Radioactive Waste Management Associates

Memo

Re: NUREG-2125 Review

Figure 3-1 Impact orientations analyzed

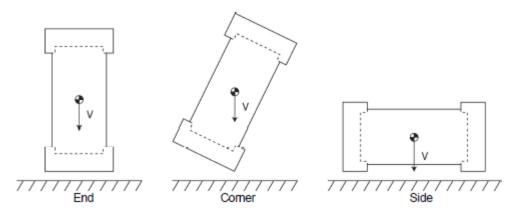
NUREG-2125 considers the standard impact orientations, shown in Fig. 3.1 below. Each of the orientations takes into account the energy absorption of the impact limiters. For the truck cask, in particular, a detailed analysis in NUREG-2125 for orientations in Fig. 3.1, was not carried out because, according to NUREG/CR-6672, there were no gaps between the lid and the cask body at any impact speed for the orientations in Fig. 3-1. This holds for a steel-DU truck cask, such as the GA-4 cask.

Though the cask orientations are interesting and satisfy NRC cask regulations, in the real world, not all impact surfaces are flat. A cask may impact a bridge column sideways, or a structure, such as the Cypress Creek structure in Oakland, CA may collapse onto a cask. These side or back- breaker impacts were also not considered in NUREG-2125, but the authors claim they were considered elsewhere. We consider the claimed references below.

Fig. 1. Cross-section of the GA-4 cask, including the propylene neutron absorber.

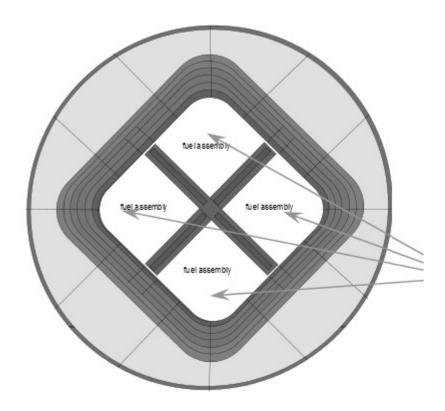
As seen in Fig. 34, the interior of the cask was modeled as a solid composite, rather than as individual fuel assemblies, shown in the cross-section of the GA-4, Fig. 1. In addition, the ends of the cask were not modeled to include impact limiters which add one-ton weights to each end of the cask, similar to a barbell.

Figure 34. GA-4 cask after 96 kph [60 mph] back-breaker impact.

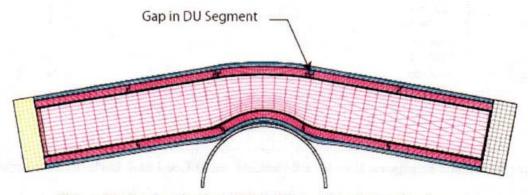
The back-breaker scenario was considered in the Package Performance Study¹ (PPT) (see Fig. 34 below). The NRC claimed "the level of strain was not high enough to cause tearing of the containment boundary and there was no permanent deformation in the closure region and no loss of containment." No "permanent deformation" does not mean "temporary displacement" when bolts stretch. As discussed below regarding the interaction of an engine train sill and cask, the bolts can stretch and the opening of the cask lid can indeed remain open. Other details, such as the internal pressure also need to be considered.

Most importantly, the bolts and cask cover were not modeled in detail in the PPT, so it is not possible to state that there was "no loss of containment." A stretching of the bolts would allow gases and fine particles to be released. Without detailed modeling of the bolt region, it is not possible to state "permanent deformation" could not occur.

Figure 3-19 Sequential views of a 129 kph (80 mph) impact of a locomotive into a GA-4 truck cask
Figure source: (Ammerman et al., 2005)

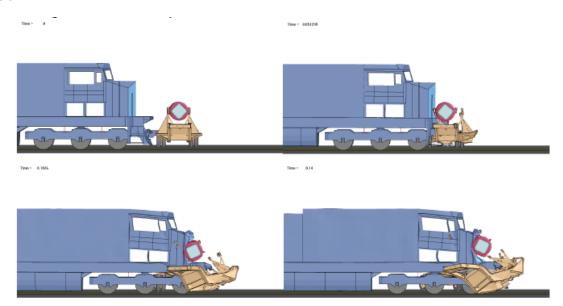
As seen, with the assumed height of the cask on the truck bed, the cask rolls into the sheet metal of the engine and is not directly impacted by the solid engine undercarriage or sill plate. The Sandia crash films show a similar scenario. But, other scenarios are possible. If the track bed at the railroad crossing were raised (hump crossing), and the truck straddled the track bed, as shown in Fig. 2 below, the solid part of the engine (sill plate) could strike the cask directly. This more serious impact was considered by Ammerman. At 70 mph, the cask bolts would stretch 0.059", above yield, and a gap of 0.043" would remain. The cask would experience forces of 140g. Some radioactive material would be released from the cask, but Ammerman could not quantify the amount because individual fuel assemblies and internal pressure in the cask and fuel assemblies were not modeled; the entire contents of the cask were one homogeneous block. Sanders *et al* ⁵ claim that the forces would need to exceed 200 g for the fuel assembly cladding to fail, but the analysis assumed the cask would remain rigid, which is not so for the back-breaker case.

Further, in the Ammerman model, the one-ton impact limiters were not included; inclusion of one-ton impact limiters would have increased the bending of the cask when struck by the locomotive.

My conclusion from the Ammerman study is that the forces on the cask bolts would exceed yield and the cask lid would open and remain open. Further, the fuel rods would break ("shatter" is a more appropriate description) and release gases and semi-volatile radionuclides, such as Cs. Far from supporting the conclusion of NUREG-2125 that no material would be released in a truck/locomotive accident, this reference contradicts it.
